ADDENDUM REPORT

Application ID: LA04/2024/1865/O

Proposal:

3no. detached dwellings part 2 storey part 3 storey (amended plans)

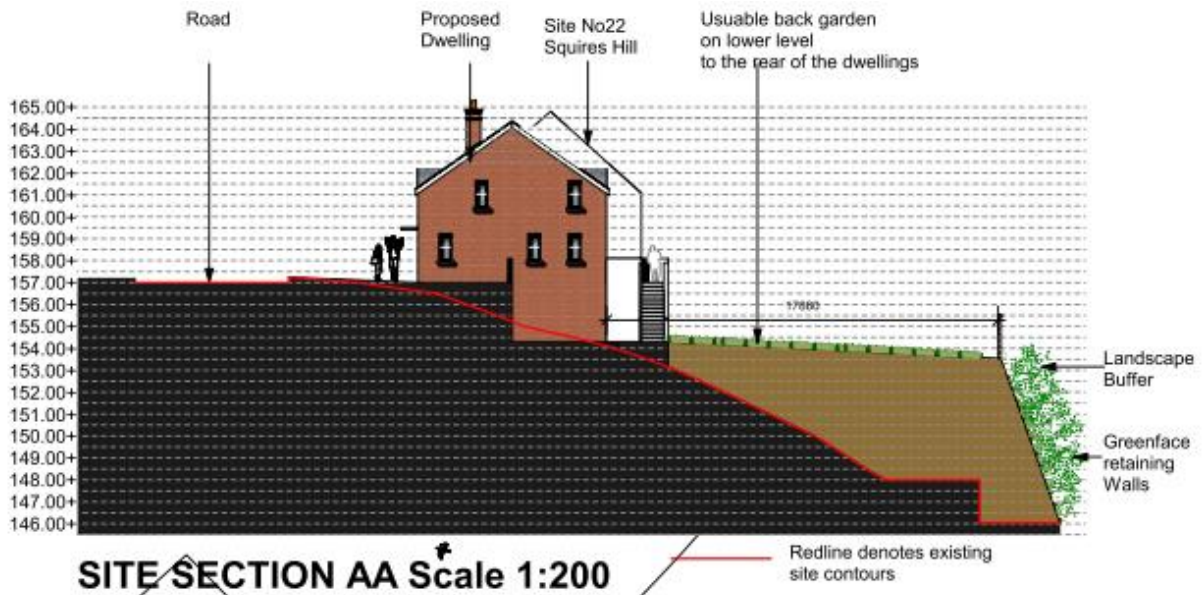
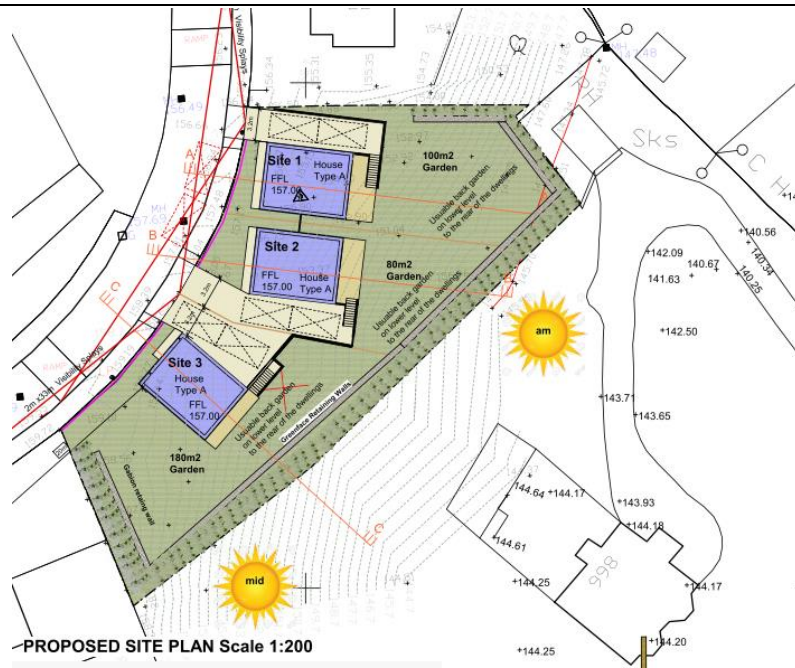
Amended plans were also received by the Council following the Planning Committee of 17th June. These plans included drawing 02A Existing Site Plan, drawing 03C Proposed Site Plan and drawing 07 Site Section through 998 which has superimposed the outline of the approved dwelling at number 998 Crumlin Road onto the site plan. The site was re-surveyed and the amended plans reflect the correct levels on site and at the site of the approved property at number 998 Crumlin Road with a FFL of 144.35. The FFL of the proposed dwellings is 157.00.

Based on the new levels provided, the impact of the proposal would remain similar to the original assessment. Paragraph 9.6 of the original report states that *"the site falls in a steep decline from west to east from 167.00 to 157.00 (a decline of 10m). Up to 2m of fill is required on the western side of the bank to create a level ground floor access (165.00-167.00)."* These figures now read that that site slopes from west to east from 157.00 to 147.00, still falling by 10m across the site. The front of the site would still require up to 2m of infill to provide level access and the levels now showing 155.00-157.00 at the front/ western boundary (drawing 03c). The level of fill required to the rear of the site remains unchanged from the original assessment.

The amended site plan and sections (03C) show that the retaining wall which is assessed under paragraph 9.10 of the original report would still be between 9-10m in height when viewed from the site at 998 Crumlin Road. The re-surveyed plans show the top of the retaining wall reaching 153.5-154.00.

Paragraph 9.12 of the original report states that *"The FFL of the dwelling at no. 998 Crumlin Road is noted as 141.00 (figure taken from the submitted site plan as part of the reserved matters planning application). The ridge height of the proposed dwellings (as shown on the sections of the submitted illustrative drawings) is noted to be 174.00. The height difference of 33m is substantial and would result in a development which is significantly dominant."* Based on the amended sections submitted under drawing 03C, the FFL of no. 998 Crumlin Road is 144.35 and the ridge height of the proposed dwellings would be 164.00, resulting in a difference in height of 20m. This is still considered unacceptable in its scale.

Proposed Sections

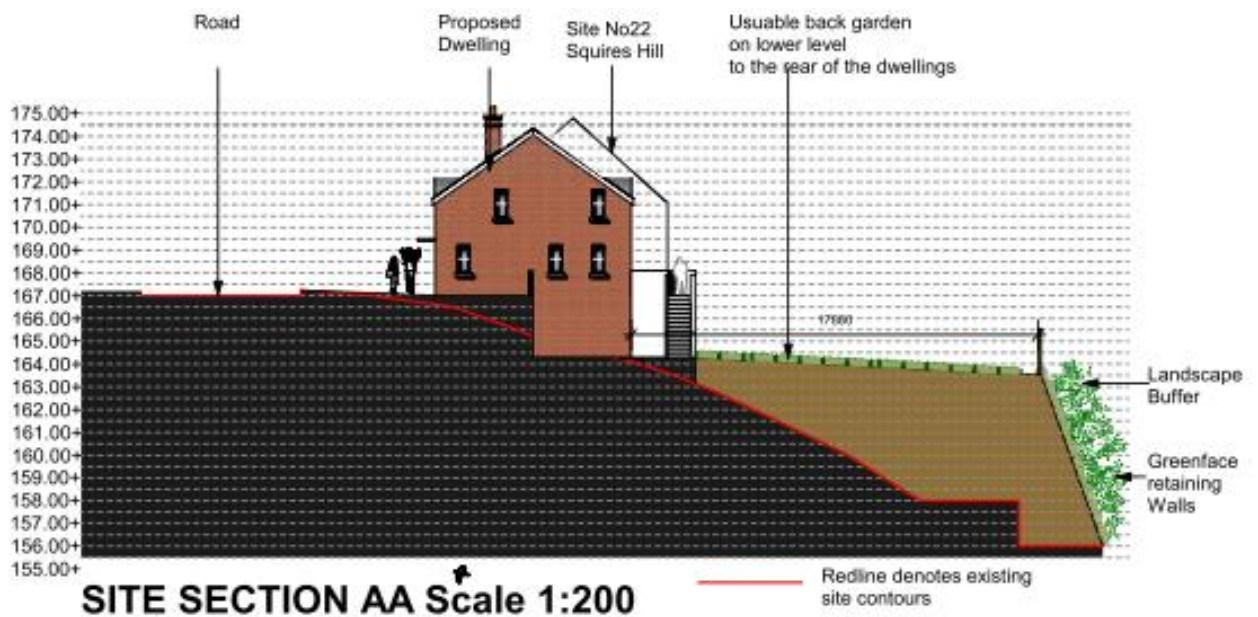
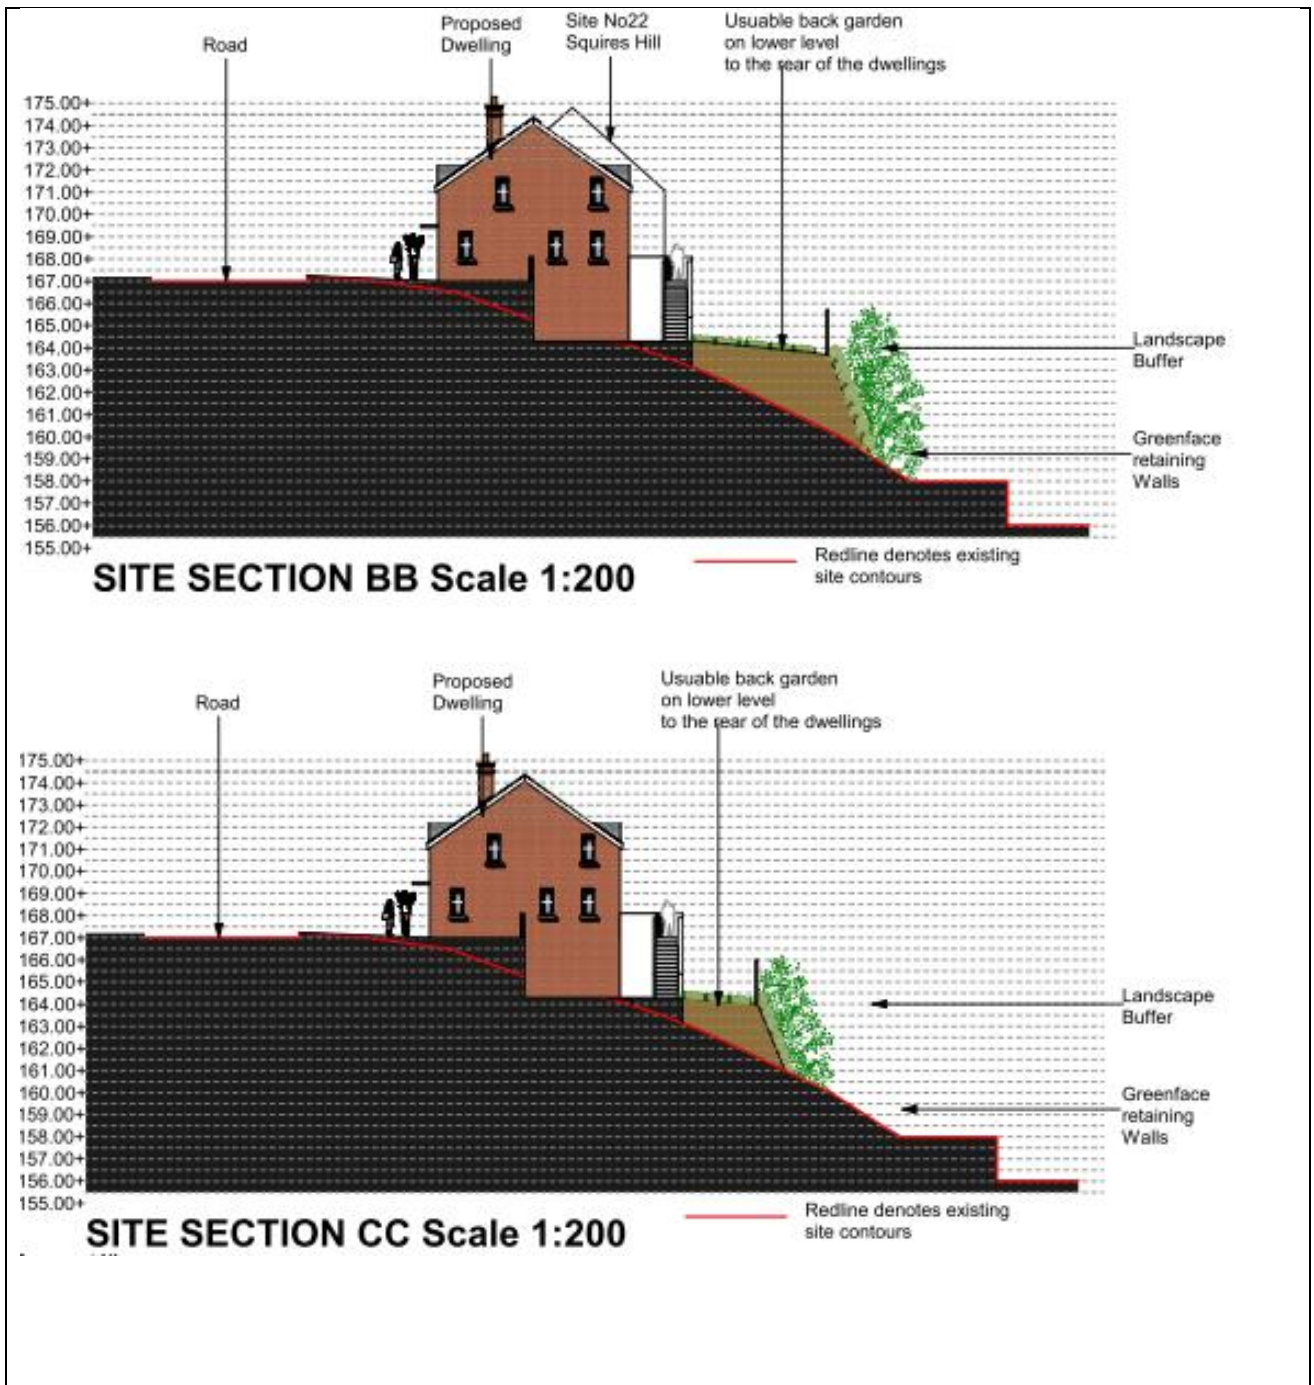
9.5	<p>The levels shown across the Proposed Site Plan relate to the existing site levels and do not reflect the proposed site levels which are shown in the sections on the same drawing no. 03B. The proposed levels are provided on the section drawings across the site.</p>

9.6	<p>The site is a steep bank within the wider residential development. The sections demonstrate that the site falls in a steep decline from west to east from 167 to 157 (a decline of 10m). Up to 2m of fill is required on the western side of the bank to create a level ground floor access (165-167). The rear garden areas require significant fill which varies in depth across the sites to create useable garden space. The property noted as 'site 1' shows infill up to 8m at the rear. 'Site 2' requires approximately 4m of fill and 'Site 3' would require 3m fill.</p>
